Re: Amendment to License 12-18215-01 and
Lixiscope Product Certification

We request amendment to our above referenced license and
product certification to add the following:

Exposure from Lixi Head Model 42 with 500mc I-125 1/24/83 BNP

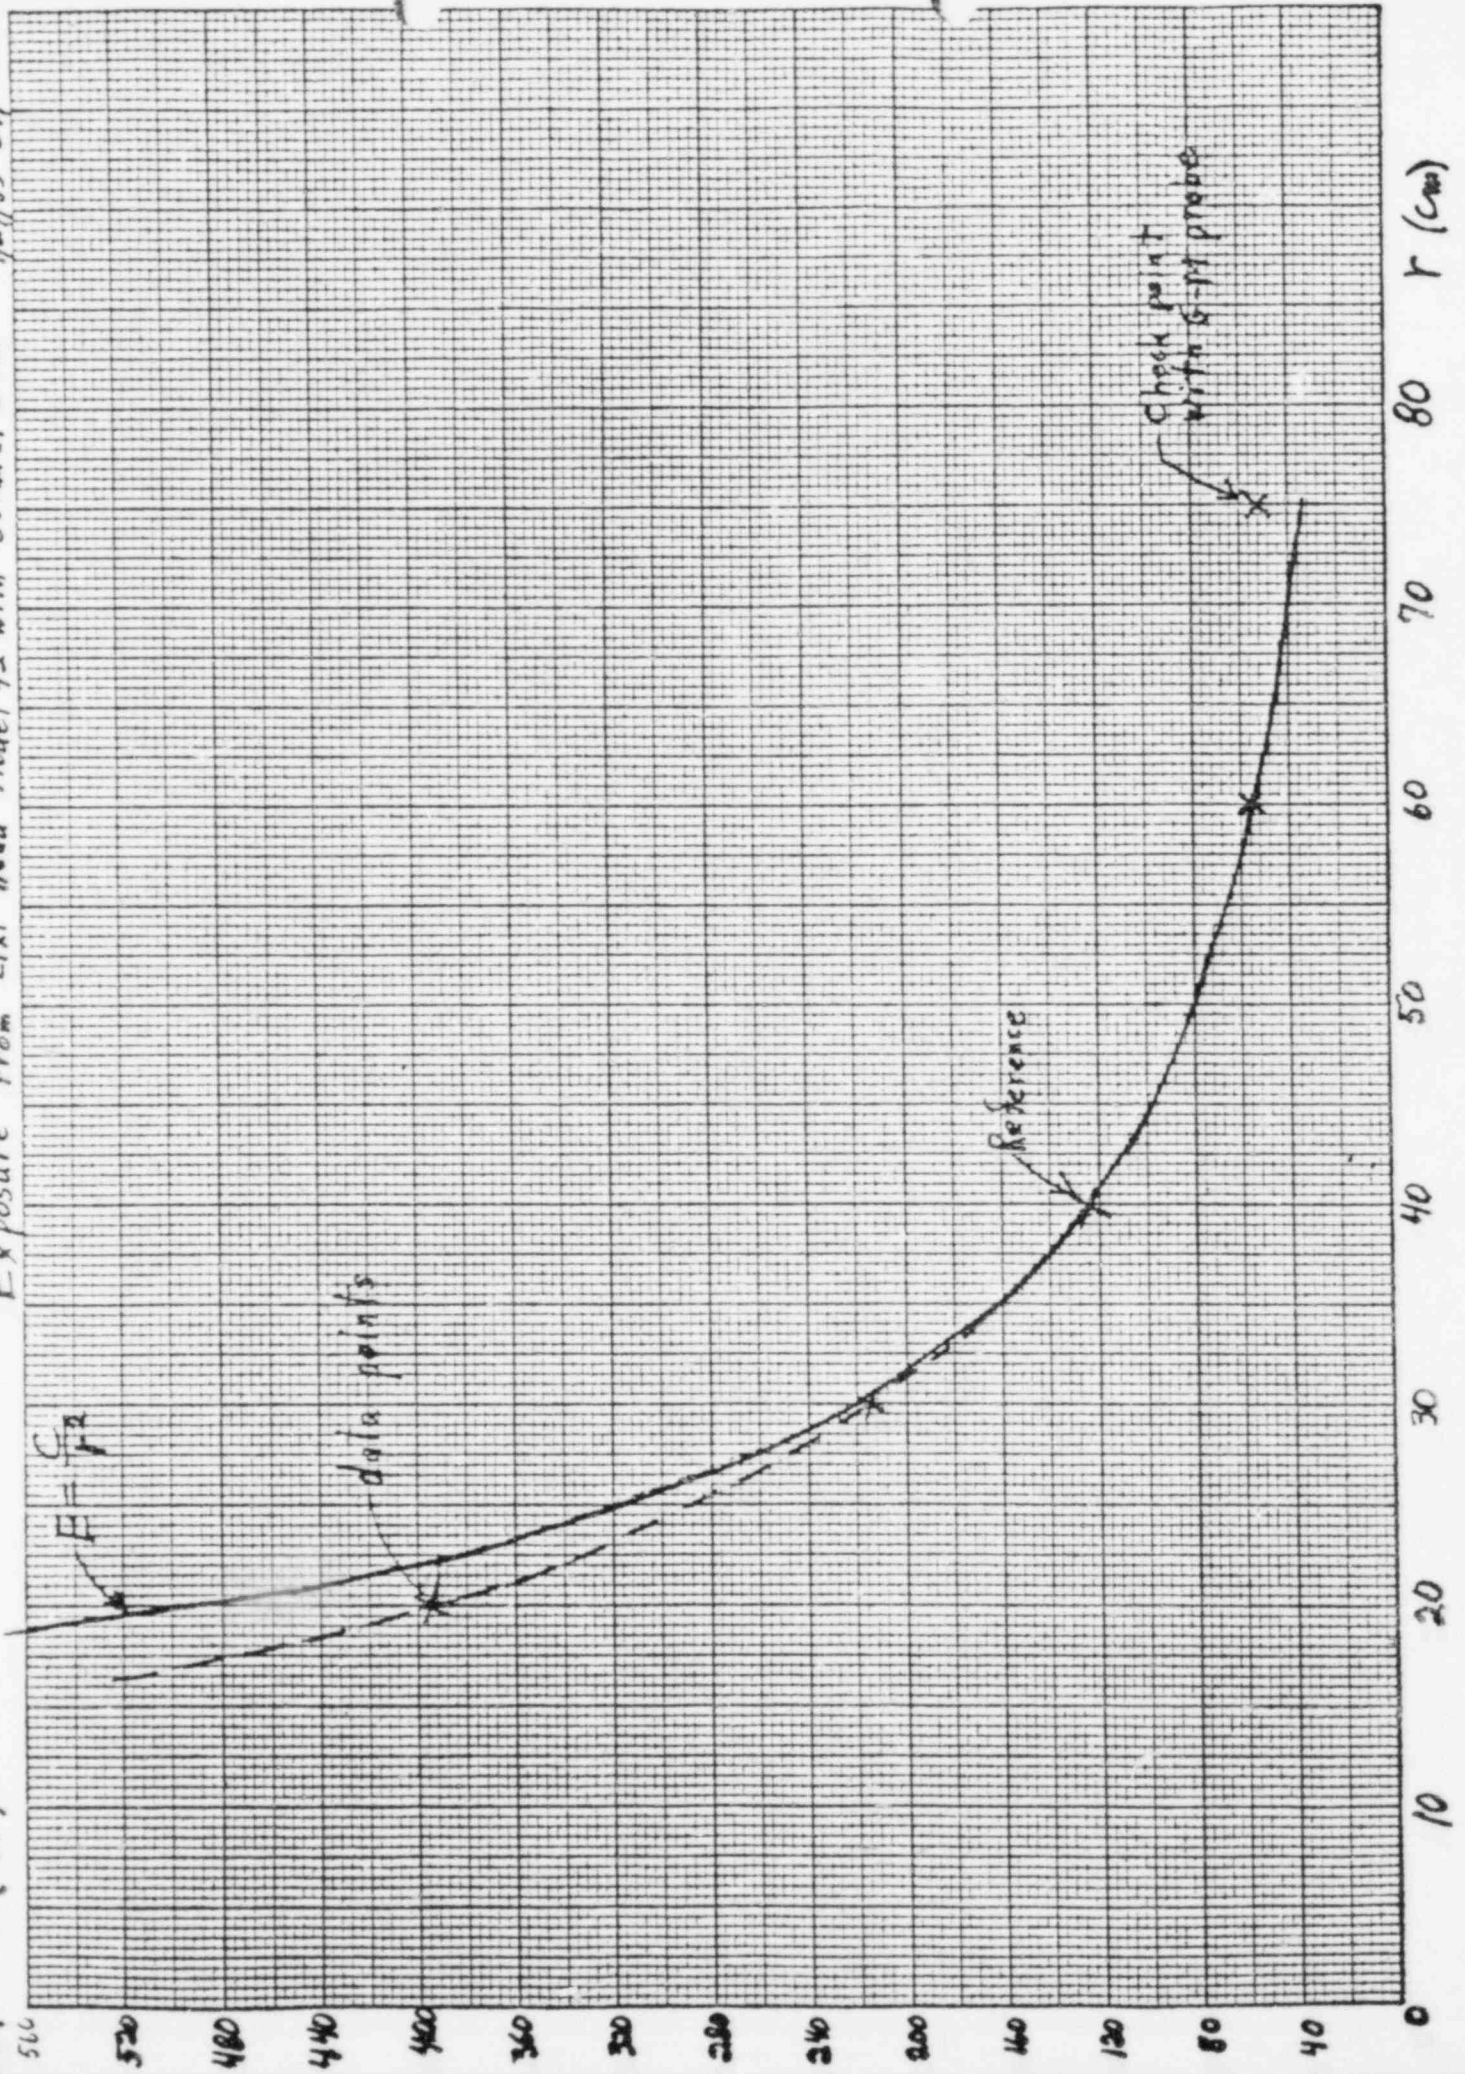
4) Maximum Exposure vs Distance from Source Holder:

Exposure measurements were taken with an Eberline RO-5B ion chamber detector. This instrument was calibrated on 1/8/82 for Cs-137 and corrected for 28keV and altitude by using a correction factor of 1.1 as recommended by the manufacturer. The measurements were taken along the beam centerline of a model 42 Lixiscope head loaded with an A.E.C.L. 253 mCi I-125 capsule. The activity was calculated for the day of test. Measurements were taken with the detector scope removed to permit different distance-exposure measurements with the ion chamber meter. The corrected data is shown on the accompanying graph normalized to an effective 500mCi source (see Enclosure 3E). $E = C/r^2$, (where E is the exposure, r is the source to detector distance, and C is proportionality constant), C is 199.2 Rcm²/hr using the 40cm point as the reference. The 40 cm point was chosen because it is the approximate midpoint of the attached graph. The calculated exposure results and observed readings are both plotted on the graph. Good agreement is seen between the calculated curve and the observed data points. The two curves become increasingly divergent as they approach the 20cm mark. This is explained by the ion chamber seeing a less uniform radiation field. At 70cm a check was made with a GM probe detector. The corrected reading was 30% above the extrapolated exposure from the equation, which is considered reasonable agreement. This exposure rate would then be 5.53r/hr or 1.54 mR/sec at 5cm from the head. Please reference our license amendment application dated September 19, 1980 and table A of the enclosed Lixiscope Instruction Manual, which reports 3.2mR/sec at the 5cm distance, normalized for 500mCi activity. Our new calculated exposure rate is about 50% of the previous reported exposure rate. This can be explained by the fact that this latest test used a two mm I-125 bead while the previous test used a one mm bead, so the specific activity difference explains this apparent discrepancy. The Table A (listed on page 16 of the Lixiscope Instruction Manual), therefore, is still applicable as being representative of "worst case" dose rates.

TOLERANCES (EXCEPT AS NOTED)		LIXI INC.	
DECIMAL ±.015		SCALE 1" = 1"	DRAWN BY SPS
FRACTIONAL ± 1/16			APPROVED BY [Signature]
ANGULAR ± 1°	DATE 8/18/82	DRAWING NUMBER LS-82-X (BENCH MOUNT)

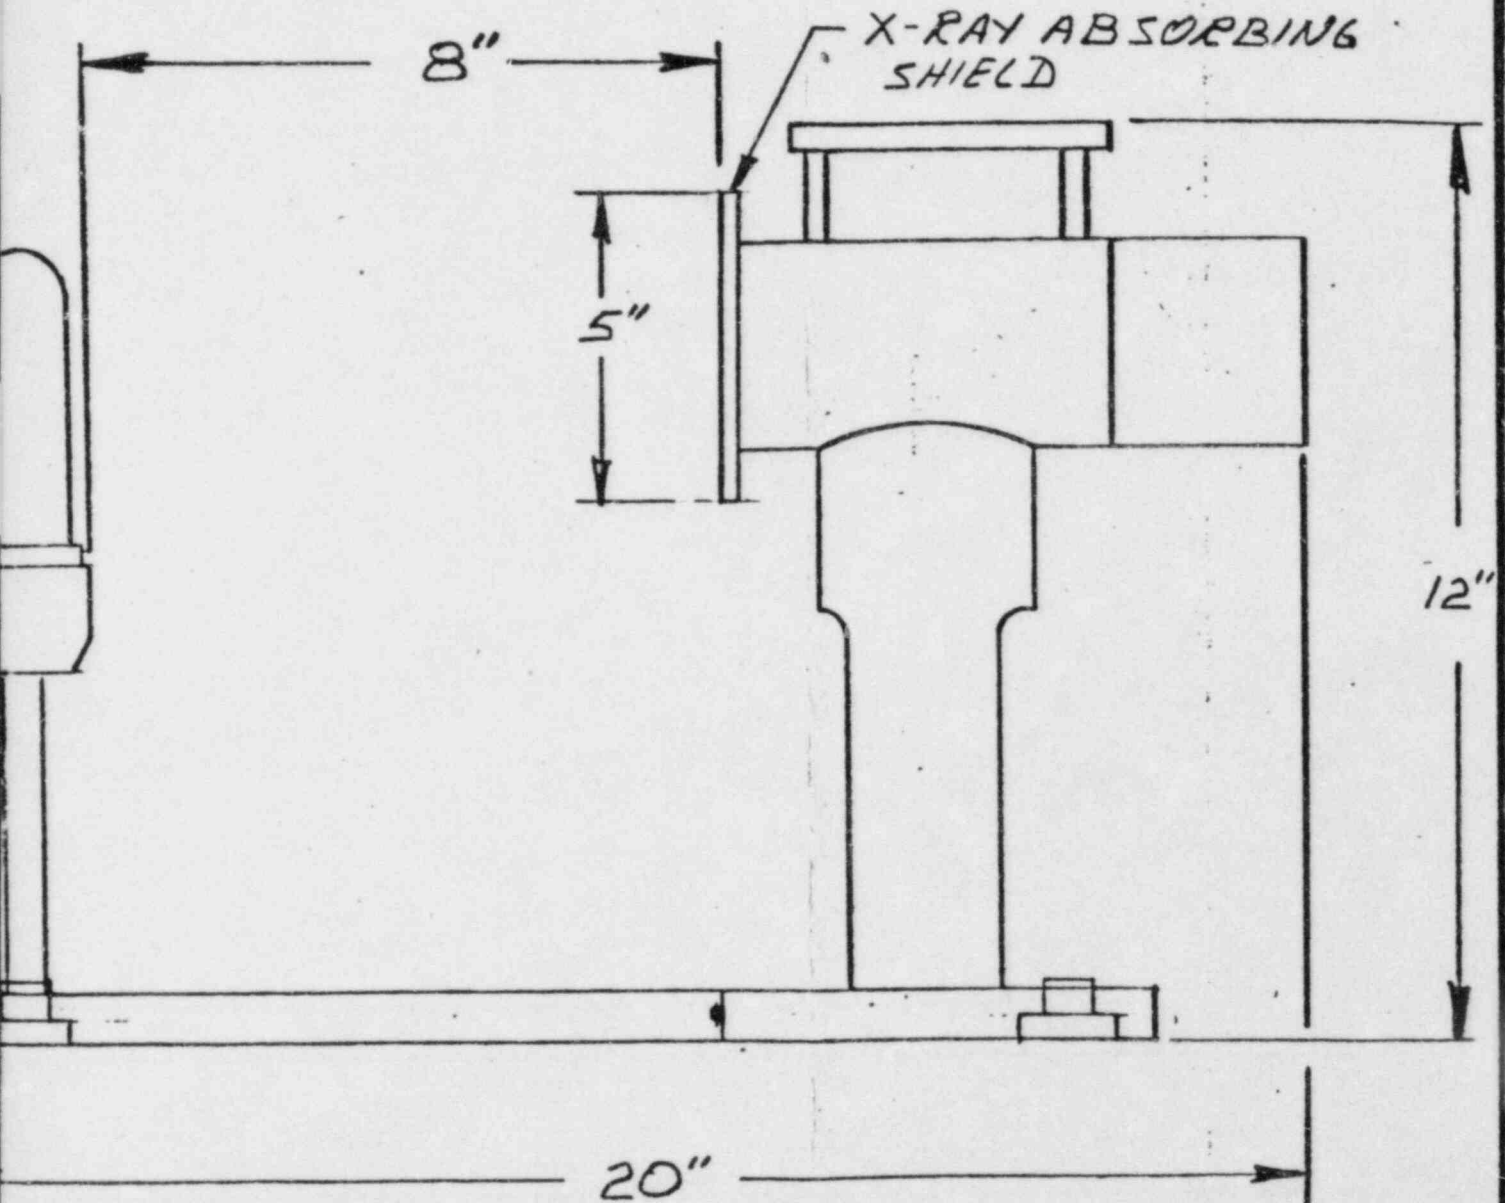
5. On bench mount models of the industrial LS-80 and LS-82 series, the "on-off" mechanism is a key switch instead of a trigger. Please see the enclosed print.
6. We have improved the source head designs to match collimation of the radiation beam to the field size of the detector scopes. In other words, the internal collimation design is dependant on the length of the distance bar with each Lixiscope. We have now assigned model numbers to the source heads to reflect this relationship. Each source head (holder) model has a pin located in such a manner as to allow only the positioning of a source head designed for the particular combination of distance bar length and detector scope field diameter. The source head has a mating hole matched up with the locating pin of the distance bar arm. The following are the source head description and models we intend to use:
